Subject: SYSTEM TIMING MODIFICATION FOR ALTAIR 88-DCDD FLOPPY DISK

Date: SEPTEMBER 2, 1977

From: MITS ENGINEERING DEPARTMENT

SYSTEM TIMING MODIFICATION FOR ALTAIR FLOPPY DISK

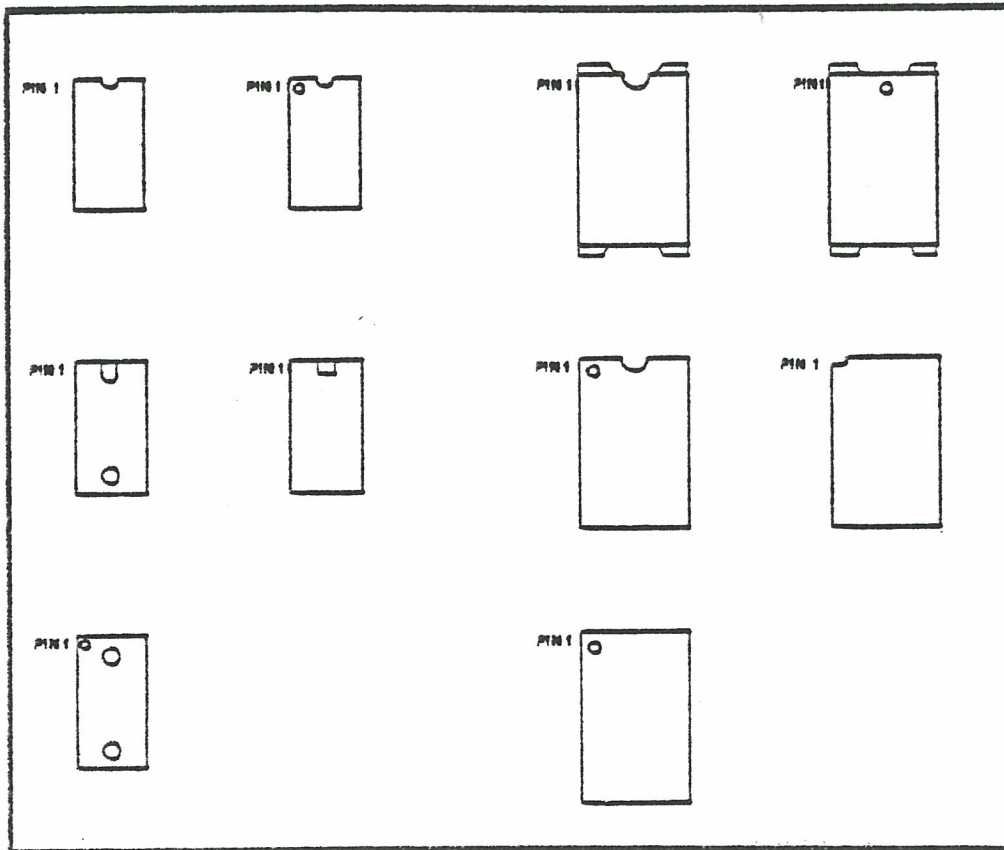
- A. Change the Write Clear One Shot timing from 280 μ s to 389 μ s.
1. Remove resistors R11 and R12. Be careful not to damage the plated portion around the holes in the PC board.

2. Install a 4.32K ohm ($\pm 1\%$ tolerance) resistor in the R11 position and a 12.1K ohm ($\pm 1\%$ tolerance) resistor in the R12 location, according to the following instructions.

- C. Change the Read Clear One Shot timing from $140\mu\text{s}$ to $214\mu\text{s}$.
1. Remove R5 and R6 being careful not to damage the plated portion around the holes in the PC board.

2. Install a 6.65K ($\pm 1\%$ tolerance) resistor in the R5 position and an 8.25K ($\pm 1\%$ tolerance) resistor in the R6 position according to the resistor installation procedures followed in Part A, Step 2 of this section.

- D. Change the schematic to coincide with the modification.
